JEFF HAMILTON STORAGE SUBDIVISION

APPLICATION NUMBER Holdover DATE August 17, 2006

DETAIL SITE PLAN

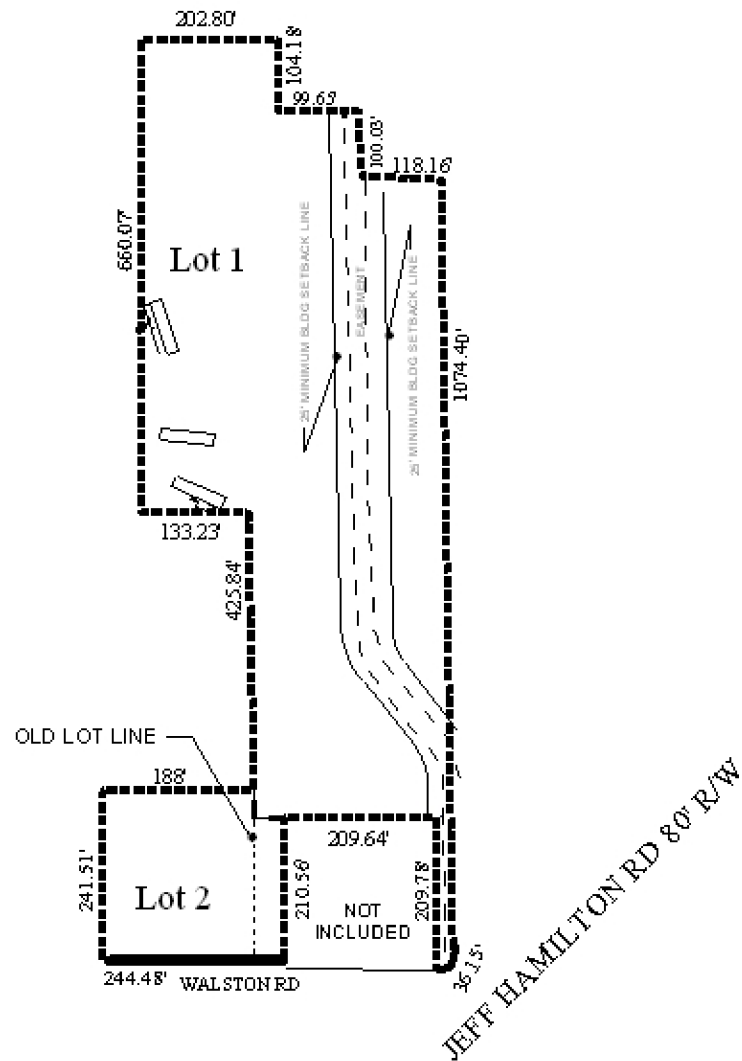
The proposed subdivision will create a lot of record, the proposed Lot 2, that only has frontage on a private street. The previous approvals for the existing lot of record included a condition denying access to the private street. The Subdivision Regulations state in Section V.D.4. that *“every lot shall abut a dedicated and maintained public street.”*

The 25-foot minimum building setback line, required in Section V.D.9., is not shown for the subdivision, but would be required on the Final Plat, if approved.

This site is located in Mobile County, thus a note should be placed on the Final Plat stating that any lots which are developed commercially and adjoin residentially developed property must provide a buffer, in compliance with Section V.A.7. of the Subdivision Regulations.

The plat is recommended for Denial for the following reasons: 1) the subdivision will result in a lot of record that does not abut a dedicated and maintained public street, as required in Section V.D.4. of the Subdivision Regulations.

The plat is recommended for Denial for the following reasons: 1) the subdivision will result in a lot of record that does not abut a dedicated and maintained public street, as required in Section V.D.4. of the Subdivision Regulations.
